# REGIONAL REVIEW FINDING

ARC REVIEW CODE: R1810021

**Name of Proposal:** Equinox Corporate Campus (DRI 2809)

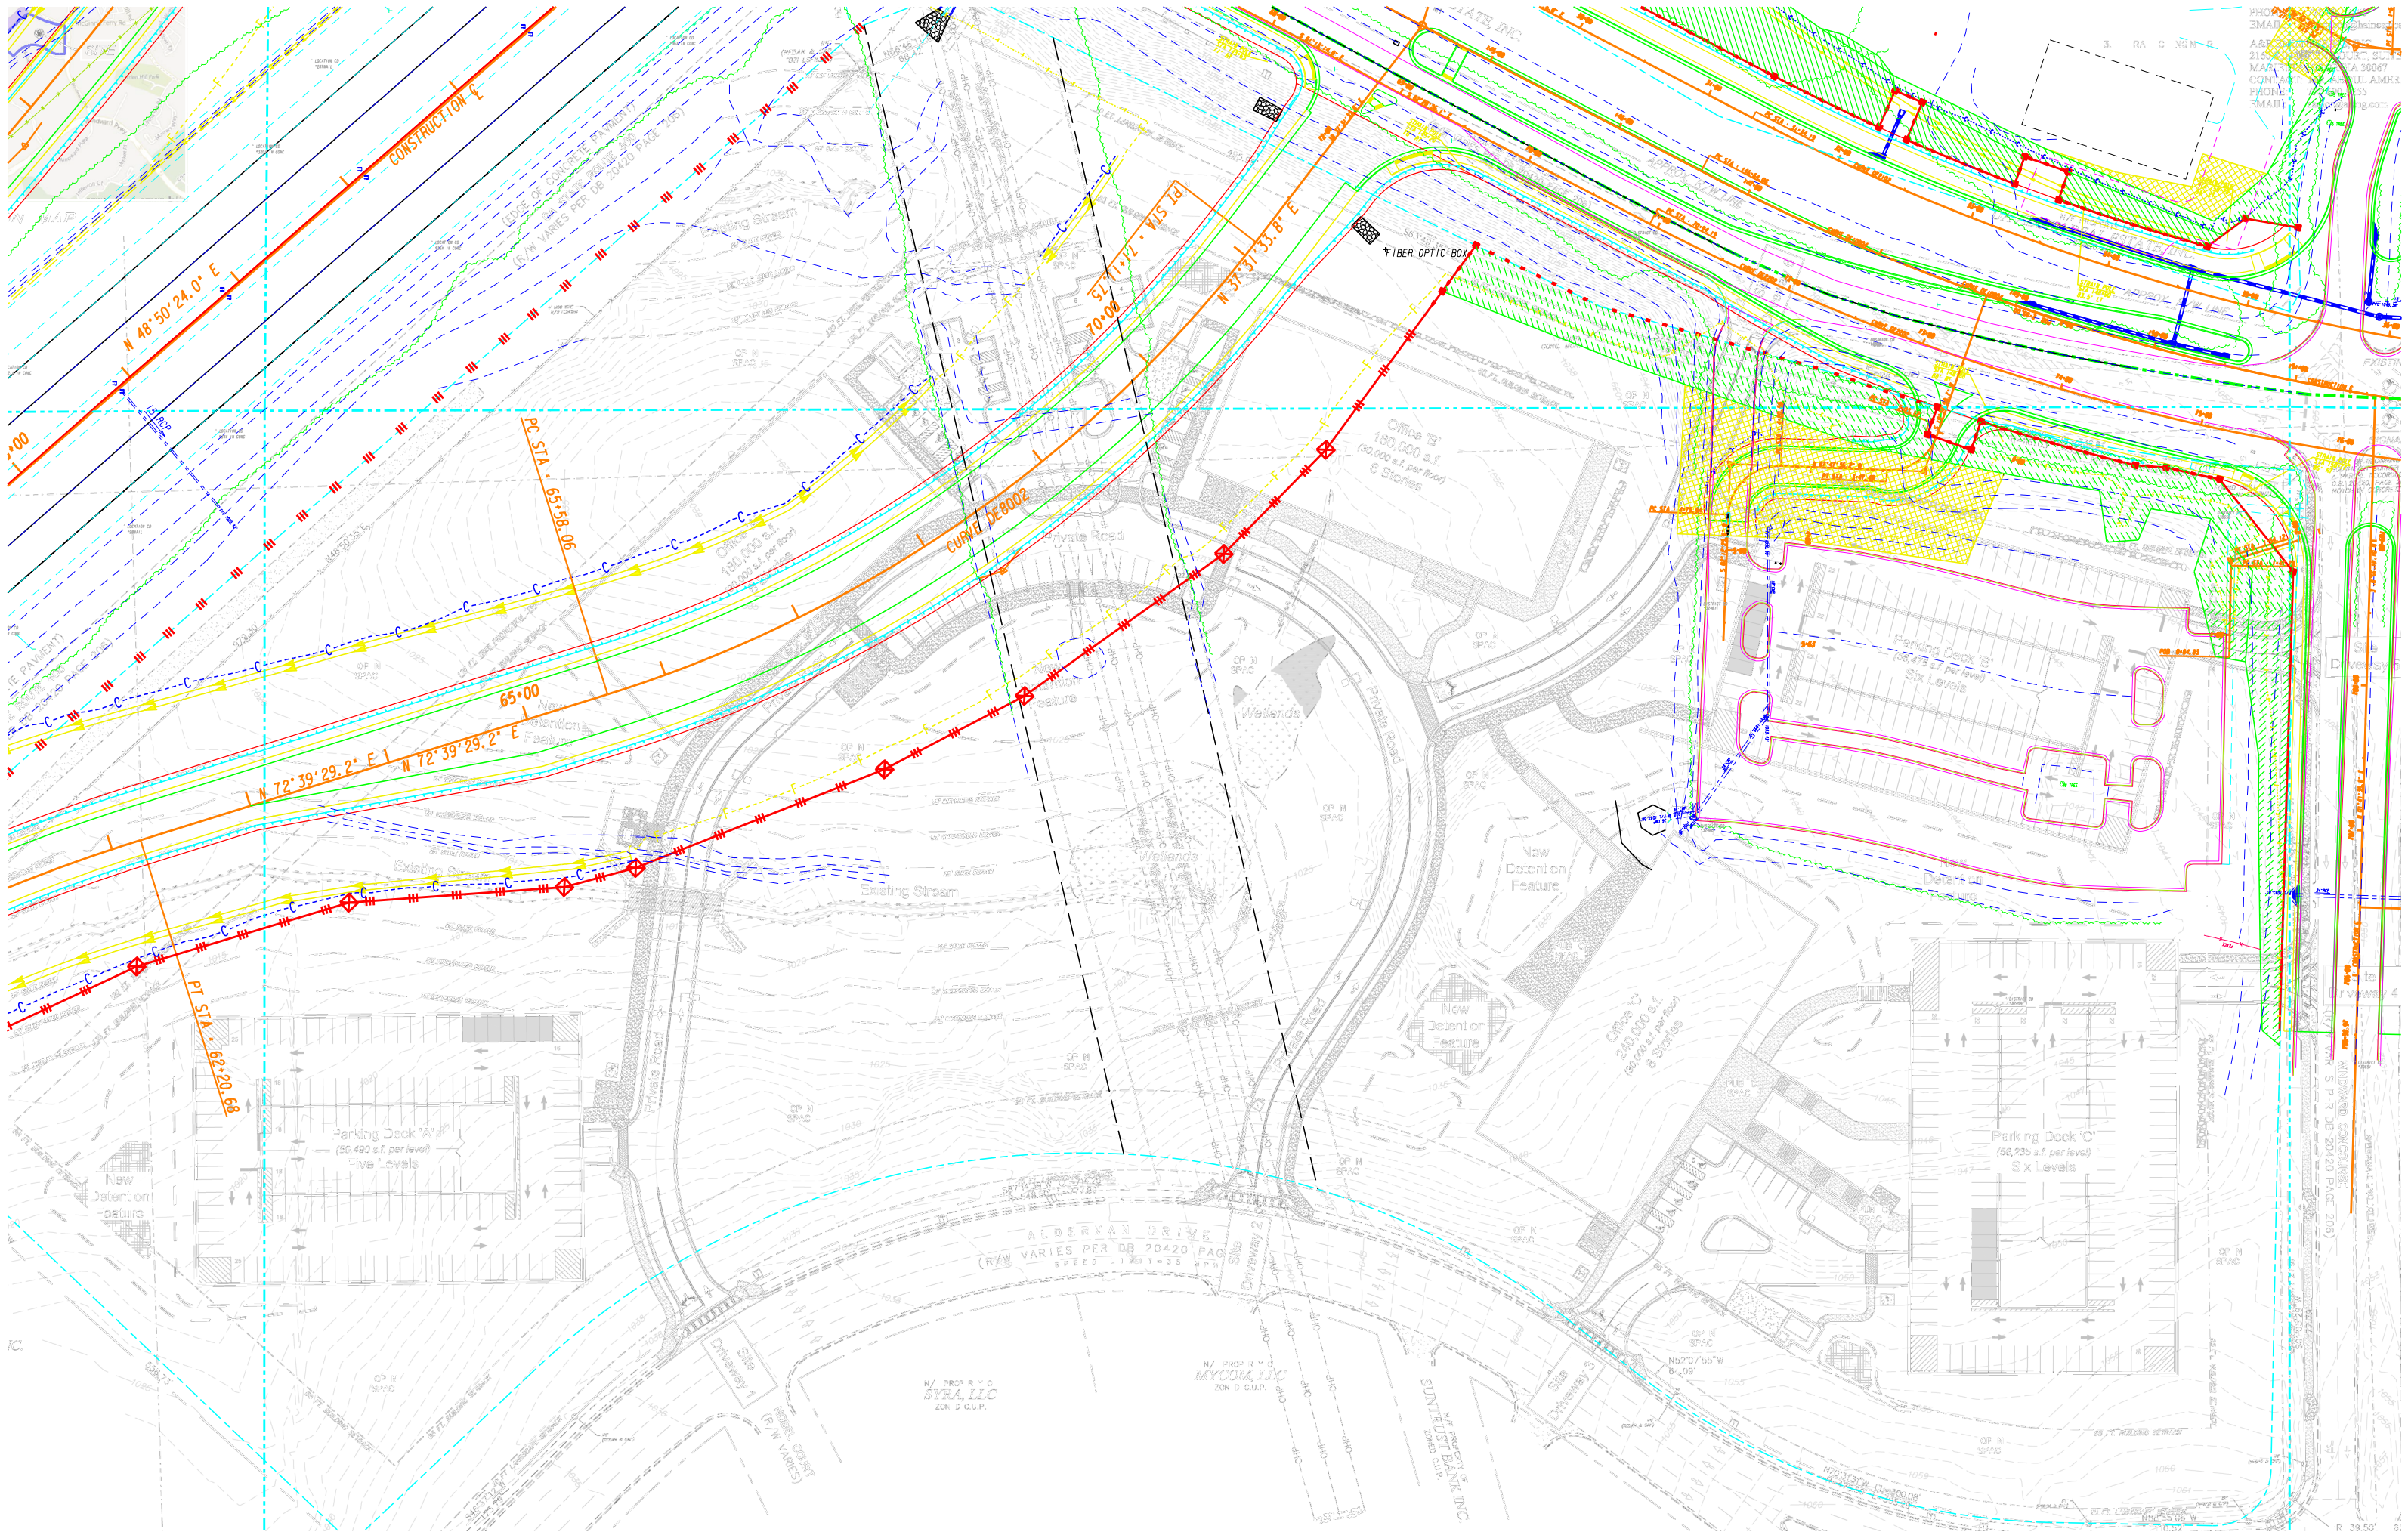
The site is in direct conflict with the SR 400 @ McGinnis Ferry Rd project. The trips in the report need to be reduced since half of the site will be impacts by the SR 400 ramp NB ramp.

Jason provided comments to GDOT back in June stating that this DRI layout was in conflict with the proposed interchange project. For reference, I've attached a copy of those comments. I'm also attaching a copy of our interchange layout superimposed over the DRI layout to show the extent of the conflict, which is drastic.

DESCRIPTION  
DATE  
NO. BY  
DRAWN BY  
CHECKED BY  
DATE  
SHEET TITLE  
GRTA DRI  
SITE PLAN  
SHEET NUMBER  
DRI-1

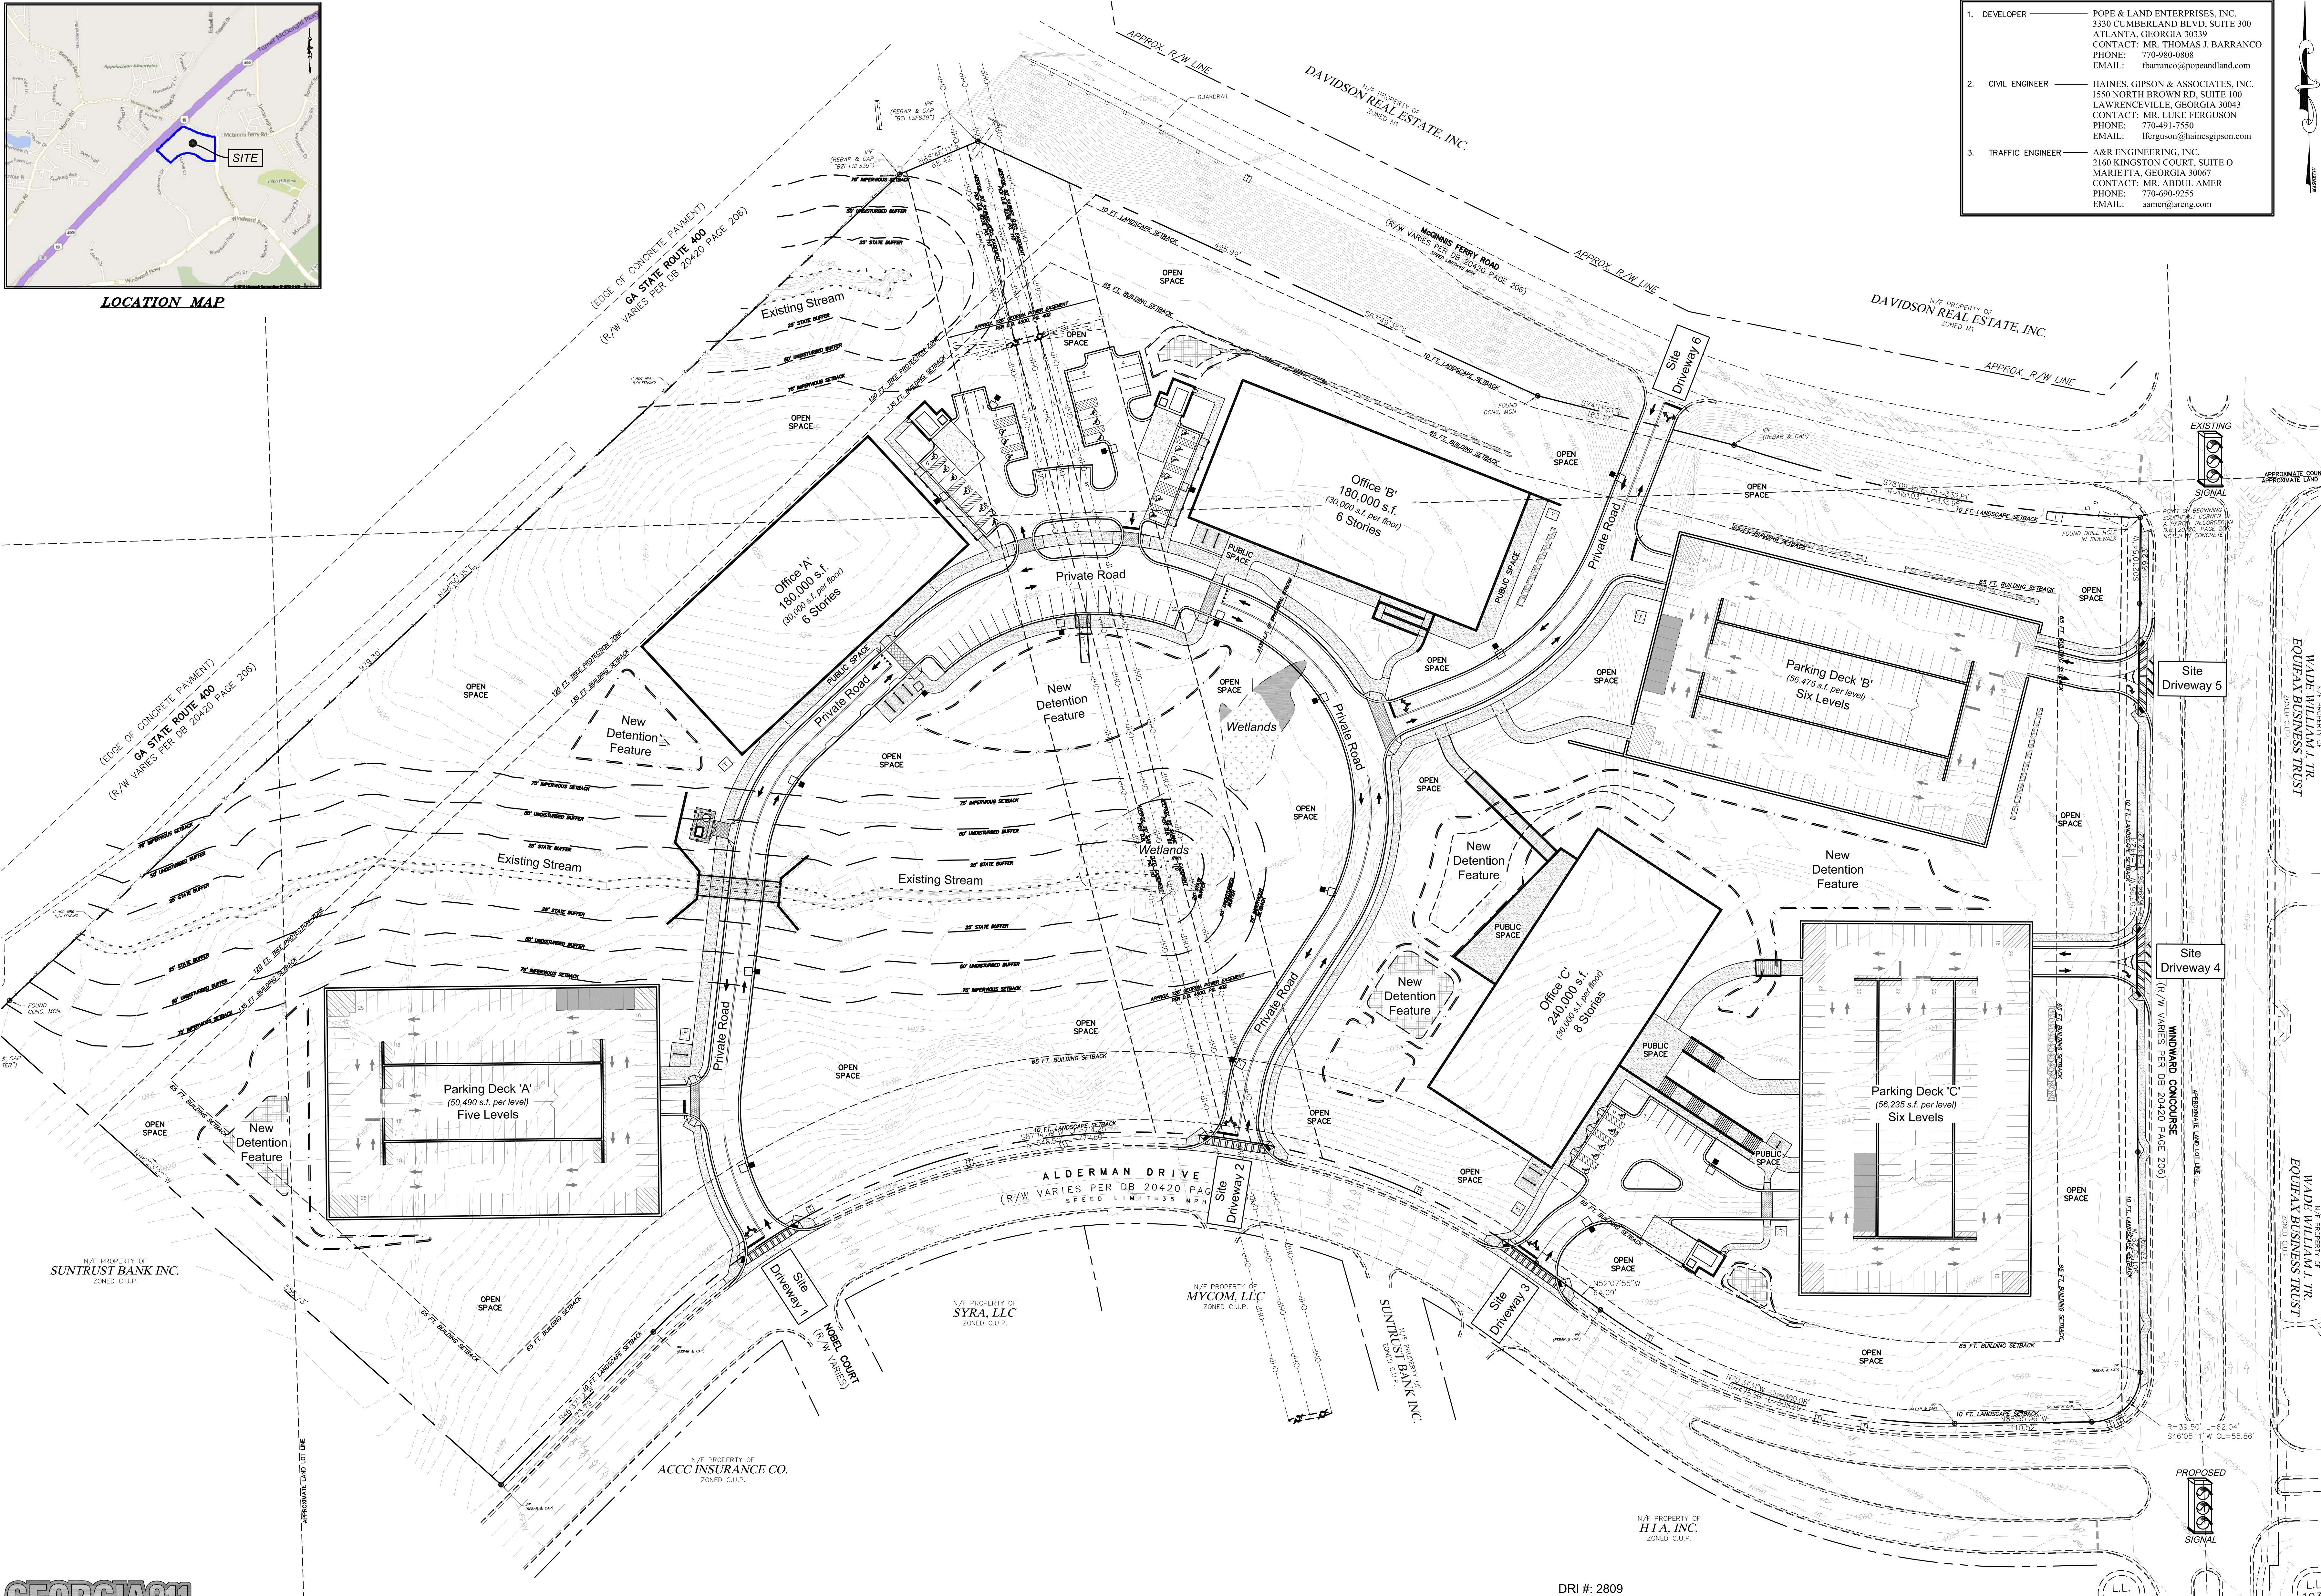
The site plan proposes pedestrian pathways connecting all office buildings and parking decks, as well as a new sidewalk on the project's Windward Concourse frontage. This new sidewalk will support pedestrian circulation in the area in general. Specifically it will allow MARTA Bus Route 143 riders to walk north from the stop (on Windward Concourse just north of Alderman Drive), enter at Driveway 4 or 5, and navigate through Parking Deck B or C to reach the office buildings. However, ARC also recommends that the development team provide a sidewalk along the project's Alderman Drive frontage, such that bus users can walk west from the stop to access the DRI site via Driveways 2 and 3. This is likely a shorter and less circuitous route to the project's office buildings than entering on foot at Driveways 4 or 5. In terms of bicycling, striping and/or signage for bike use is already present on Windward Concourse, Alderman Drive and Windward Pkwy., and the project is within a relatively short biking distance from nearby residential and commercial areas. The development team is therefore encouraged to ensure that end-of-trip facilities (bicycle racks, showers, etc.) are provided for workers at key locations on site. This framework can offer the potential for workers to commute by bike, and it can offer those workers access to certain daytime needs

Along those lines, significant coordination will also be required regarding the planned new full diamond interchange at GA 400 and McGinnis Ferry Road (GDOT project PI No. 0007526), immediately adjacent to the DRI on the west; the project also contemplates widening McGinnis Ferry Rd. on the east side of GA 400 to a six-lane, median-divided roadway with auxiliary lanes in the vicinity of the DRI site. The DRI and the GDOT project are on similar buildout timelines (2020 for the DRI and 2022 for the GDOT project). **Importantly, according to comments received from GDOT District 1 and Forsyth County during this review (both attached to this report), the layout of the DRI is in "direct conflict" with that of the programmed interchange.** Therefore it will be critical that the development team, GDOT, the City of Alpharetta and Forsyth County maintain close, ongoing coordination regarding the interchange's design, right-of-way and construction as they relate to this DRI's design and construction, in order to resolve this conflict.
